STAFF REPORT
COMMUNITY DEVELOPMENT DEPARTMENT

HEARING DATE: 4/20/2023
DATE: (Continued from: 11/2/22, 12/15/22, 1/19/23, & 3/2/23)
TO: Planning & Zoning Commission
FROM: Sonya Allen, Associate Planner
208-884-5533
SUBJECT: H-2022-0013
Promenade Cottages Subdivision
LOCATION: 403 E. Fairview Ave., in the NW 1/4 of Section 7, Township 3N, Range 1E. (Parcel #S1107212707)

- Rezone of 6.82 and 0.33 acres of land from the R-8 and C-G zoning districts to the R-40 (6.61 acres) and C-G (0.54 acres) zoning districts;
- Preliminary plat consisting of 45 building lots [30 single-family residential building lots, five (5) multi-family building lots, two (2) commercial building lots] and eight (8) common lots on 7.64 acres of land in the R-40 and C-G zoning districts;

B. Preliminary Plat (dated: 4/7/2023)

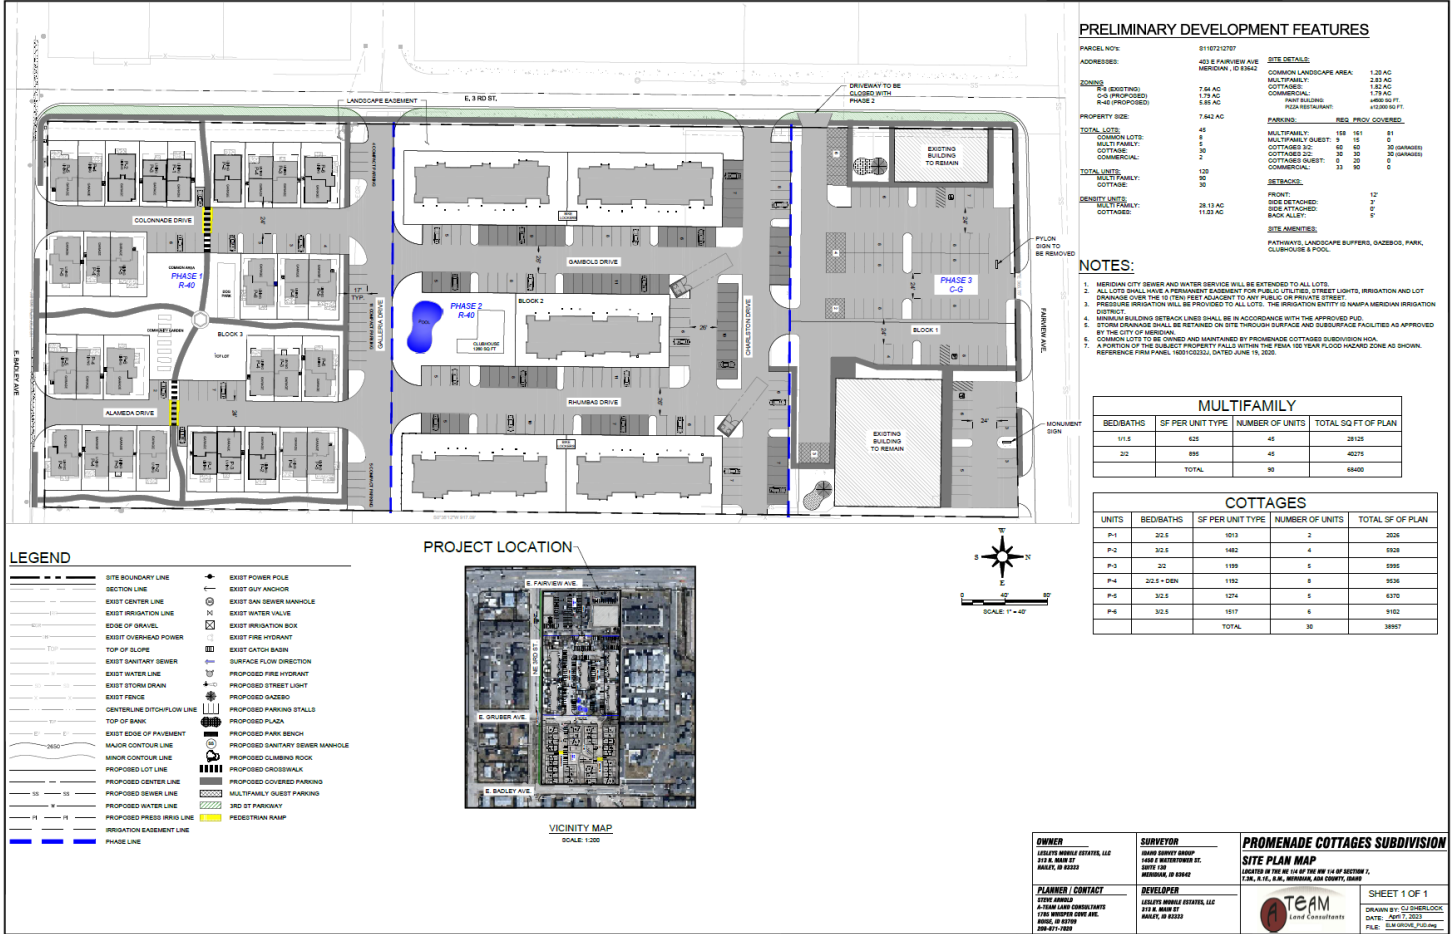
- b. Remove the western-most driveway access driveway via E. Fairview Ave. on the commercial portion of the property as it does not meet ACHD policy.
 - c. Remove one of the two driveway accesses via E. Fairview Ave. in front of the existing multi-tenant building in accord with UDC [11-3A-3](#), unless otherwise waived by City Council.

- f. Depict the private streets within a perpetual ingress/egress easement on the common lot(s) to delineate them from parking areas.
- 2.2 The landscape plan included in Section VII.C shall be revised as follows:

D. Site Plan (dated: 4/7/2023)

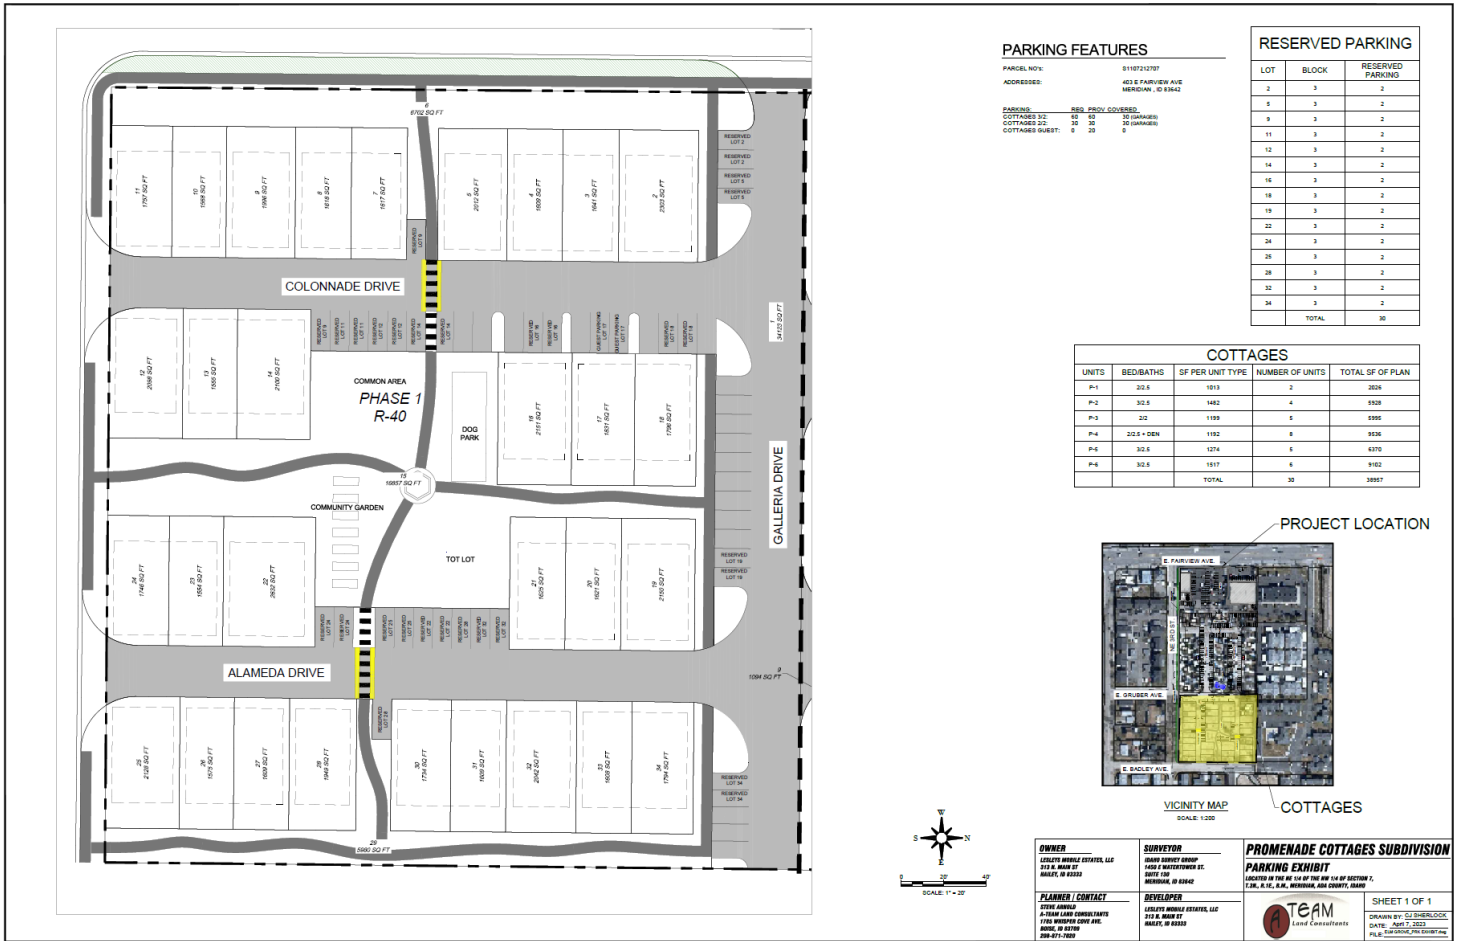
Based on the number of vehicle parking spaces proposed (i.e. 176), a minimum of seven (7) bicycle parking spaces are required per UDC [11-3C-6G](#) that comply with the standards listed in UDC [11-3C-5C](#). Bike racks should be provided in central locations for each multi-family building and the amenity building. Bicycle parking should be included on the site plan in accord with these standards.

*Based on 90 multi-family units, a minimum of four (4) amenities are required with at least one from each category listed in UDC [11-4-3-27D.1](#). The site plan depicts the following amenities: a swimming pool, clubhouse, dog park, community garden and a tot lot from the quality of life, open space and recreation categories. **An additional amenity should be provided from the multi-modal category.***

- 3.2 The site/landscape plans submitted with the Certificate of Zoning Compliance shall be revised as follows:
 - a. All on-site service areas, outdoor storage areas, waste storage, disposal facilities, and transformer and utility vaults shall be located in an area not visible from a public street, or shall be fully screened from view from a public street in accord with UDC [11-4-3-27B.2](#).

- b. Depict the location of the property management office; maintenance storage area; central mailbox location, including provisions for parcel mail, that provide safe pedestrian and/or vehicular access; and a directory and map of the development at an entrance or convenient location for those entering the development in accord with UDC [11-4-3-27B.7](#).
